Charlotte Department of Transportation Memorandum

Rezoning Petition 15-058: Approximately 7.1 acres located on the Subject:

> southwest corner at the intersection of Morrison Boulevard and Sharon Road

Figure 1

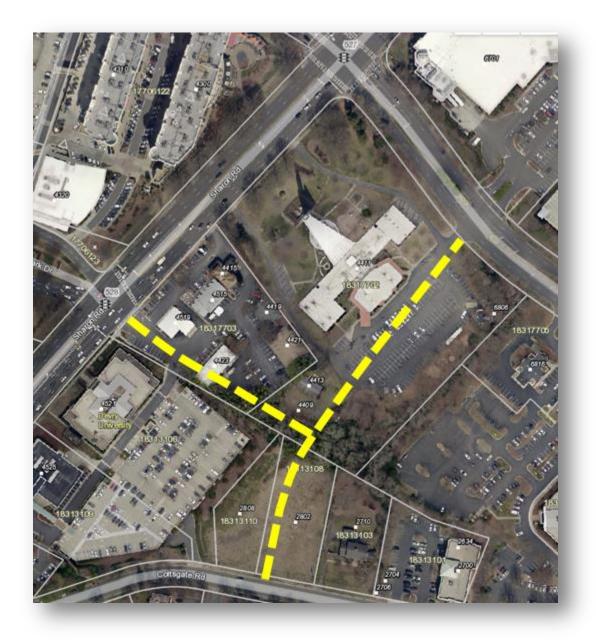
1. We recommend that the site plan stub towards Sharon Road at a location that could be extended in the future to connect with the existing signalized entrance to Southpark Mall. (see Figure 1 below).
